CITY OF MISSION
MEMORANDUM

SUBJ: ENFORCEMENT OF APPROVED DRAINAGE PLAN

This memo is to provide the residents of Aladdin Villas Subdivision and their contractors with a description of the Approved Drainage Plan for the Subdivision and the procedures for the enforcement of it.

EXHIBIT 'A'

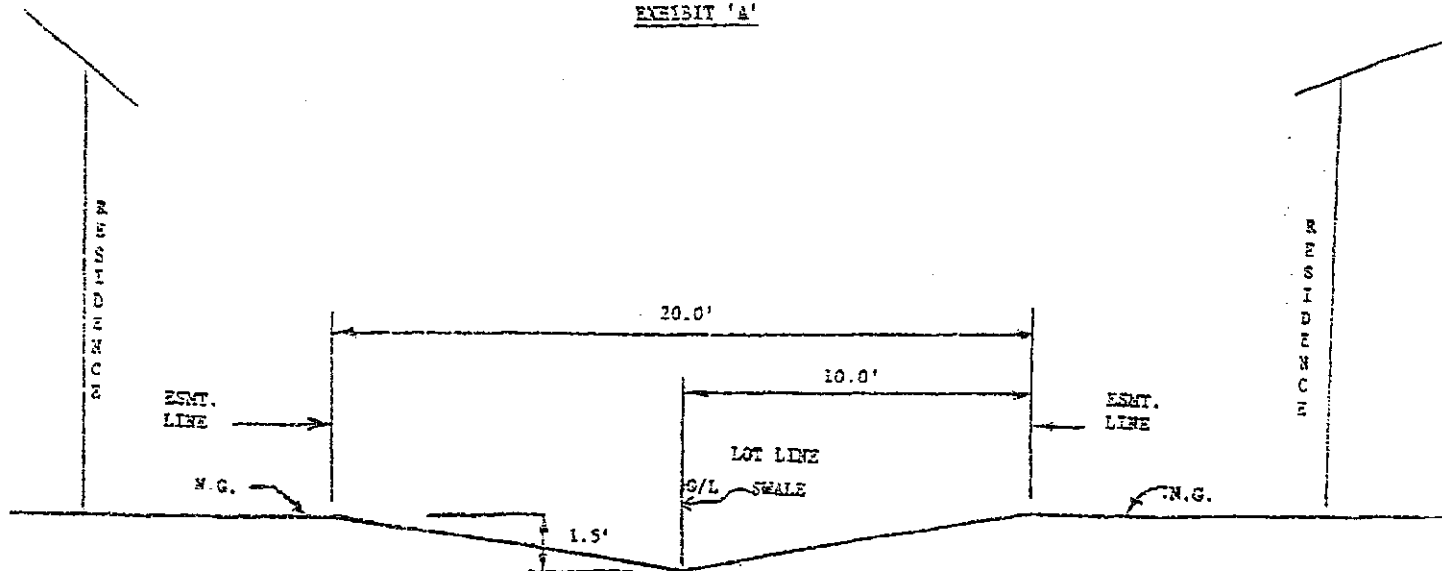
1. Attached as 'Exhibit A' is the typical rear on-lot drain swale that all interior (not located along outer boundary of subdivision) lots are required to have. Swales function to collect, store, absorb and eventually conduct runoff to drainage inlets. Thus they should not be filled with earth, gravel or any material, but rather maintained by the property owner to at least the minimum depth and shape shown in Exhibit A. Sanitary sewer manholes are intentionally placed at substantially higher elevations than the swale elevation, so that water in the swale will not enter the sanitary sewer through the manhole.

MAP

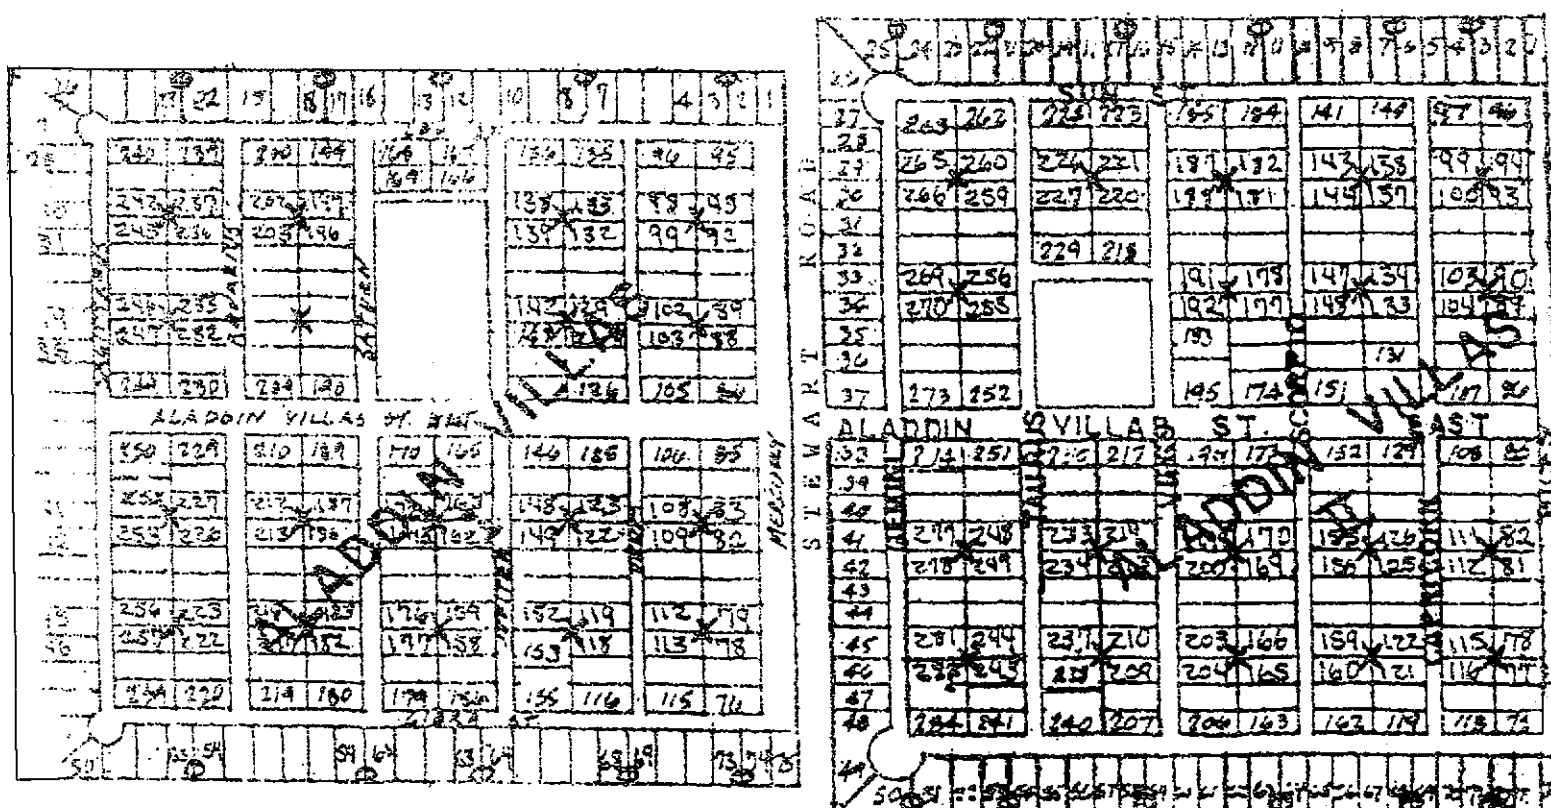
2. As shown in Exhibit A, cross berms 4-inches high x 12-inches wide are required at locations designated by X's on the accompanying map in Exhibit A. These berms act as small dams to detain and store storm water in the swales for absorption and percolation into the ground with reduced runoff. For properties having deep side-yard swales, the length of these 4-inch-high cross berms must extend 2 or more feet in each direction from the X into the side-yard swales so that the cross berms are effective in impounding water.

2. The 4-in-high cross berms shown in Exhibit C are required at locations designated by O's on the map accompanying Exhibit A. For a property having a deep side-yard swale at a location designated by an O, the length of the 4-inch-high cross berm must extend 1 foot or more into the side-yard swale so that the cross berm is effective in impounding water.

EXHIBIT 'B'

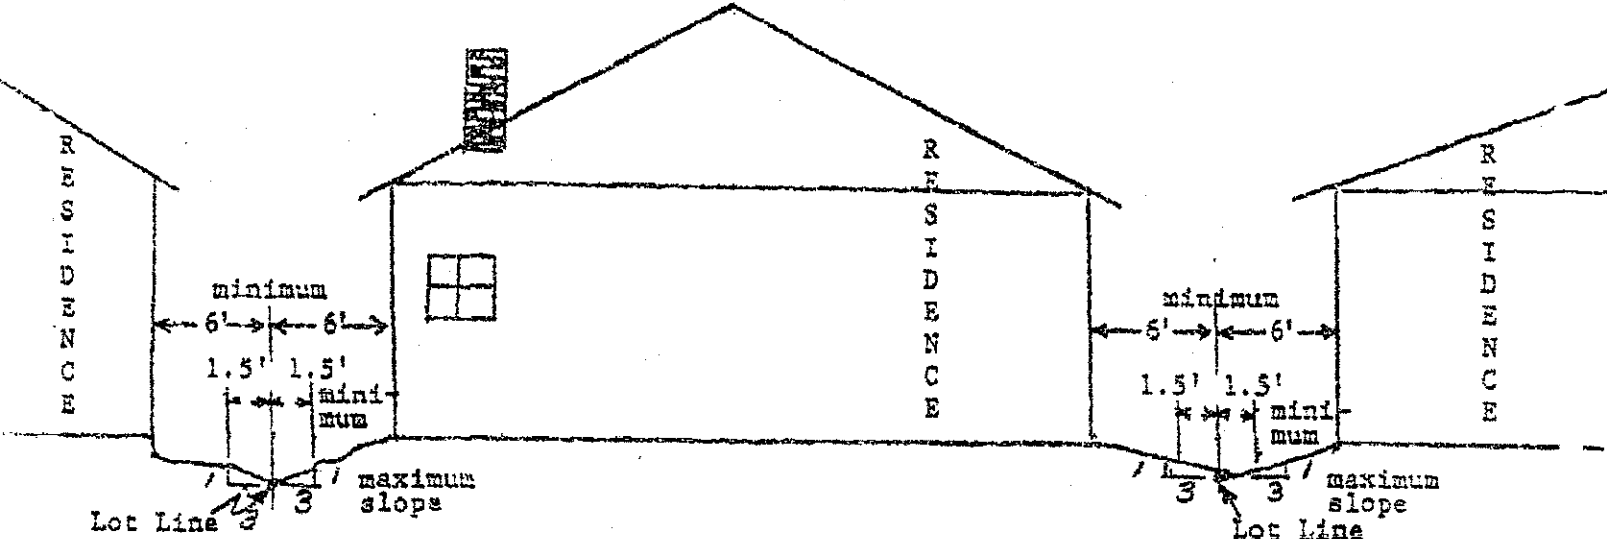
1. Attached 'Exhibit B' shows typical side-yard swales that are needed along the areas between the sides of houses to conduct runoff from the streets to the rear on-lot drain swale. Starting at the elevation of the street gutter in front of the residence, each side-yard swale must have at least 1.5 inches fall from the gutter to the center of the rear on-lot drain swale.
2. For stability and safety, the slopes of the sides of this swale must not exceed 1 vertical to 3 horizontal as shown in Exhibit B. Also shown is the minimum permeable width of 1.5 feet on each side of the side property line (3.0 feet total total permeable width) that is required to provide absorption of runoff. The elevation of any concrete sidewalks, runners or driveways on the remainder of the side setback must be low enough to accommodate these Side-Yard Swale specifications.

Each Side-Yard Swale Shall Have 1.5-Inch Minimum Fall From Street Gutter To Center of Rear On-Lot Drain Swale.

EXHIBIT 'C'

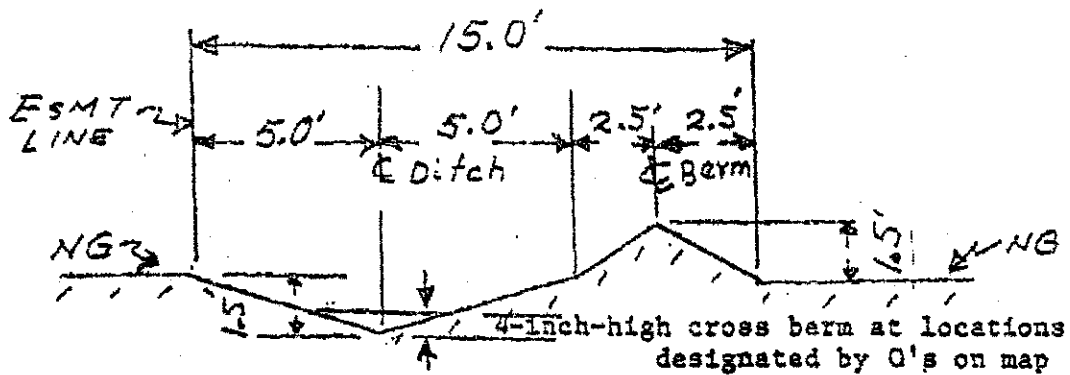
1. With the exception of boundary lots along Gemini Street, all other boundary lots are required to have a Boundary Berm with ditch as shown in 'Exhibit C'. On lots 20 through 25 and 50 through 58 of Phase II, the 18-inch-high berm shown in 'Exhibit C' is required, but a ditch depth less than 18-inches is acceptable.
